Hornsby Ku-Ring-Gai Hospital Stage 2 – State Significant Development Project (SSD 8647)

Response to Submissions Report
NSW Health Infrastructure
26 February 2018

Response to Submissions Report – SSD 8647 – HKH Stage 2 Redevelopment

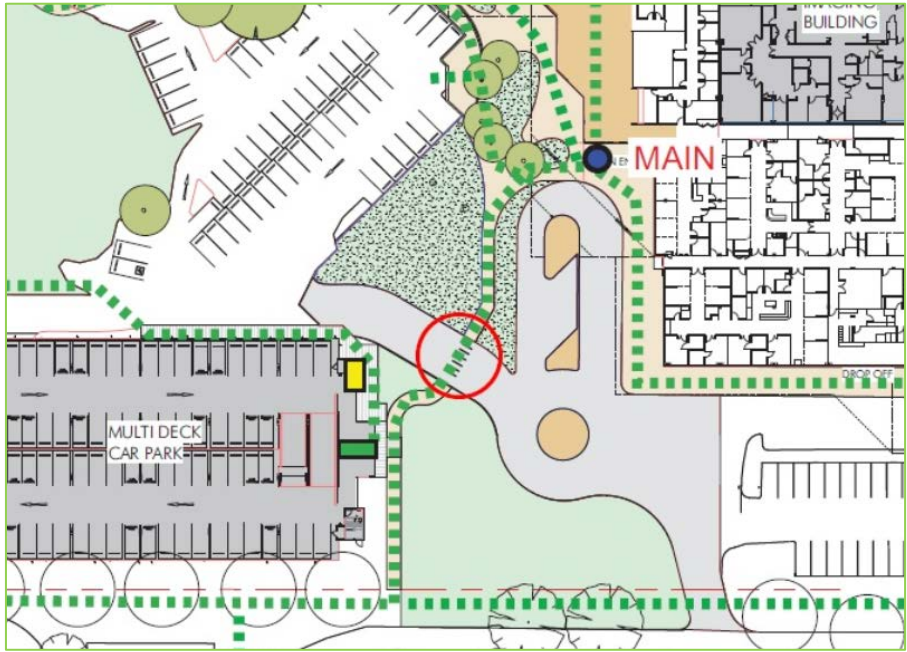
2.14	Government Architect NSW	The location of the main entry should be reconsidered or additional entries provided that respond to the needs of visitors and staff arriving from the north and the east (from a future through site link). More space should be given around the main entry both inside and outside the building.	The Nettleton Tribe Design Report offers the below advice concerning the design rationale relating to the main hospital entry: <i>The main entry and emergency entry are both clearly identifiable from Palmerston Road from both a car and pedestrian approach. The priority at the entry has to be balanced between pedestrian and car, the requirement to get the car drop off point as close to the main entry doors as possible is to minimise distance of travel for less mobile people; many of the patients/outpatients are significantly less mobile.</i> <i>The main pedestrian approach from Palmerston Road is via a landscape area located between the main vehicle entry and the multi storey car park. This landscape zone has sufficient width (up to 20m) to provide separation from vehicles. There is a crossing on this pedestrian entry pathway across a one-way link driveway.</i> <i>There are 2 existing pedestrian entry points on Palmerston Road that are maintained, one at the emergency entry and the other at the mental health building at the northern end of the site.</i> <i>Vehicles access the site from Palmerston Road and drop off at either the main entry or emergency entry. Once carers have dropped off patients at either entry they will access the multi storey parking structure, which is done via the one-way link driveway. Once the car has dropped off the patient it is expected that the carer will park the car and return to then assist the patient. The link driveway means vehicles do not go back out</i>	Appendix C - Project Architect Design Response

ITEM	LETTER	MATTER RAISED	RESPONSE	REFERENCE
			<i>onto Palmerston Road and the re-enter the site at the norther driveway crossing. This would have a negative impact on the traffic flow and also cause confusion and the potential for disorientation.</i> Having regard to the above, it is considered that the proposed main entry stands as being an appropriate response to the needs of the HKH Campus.
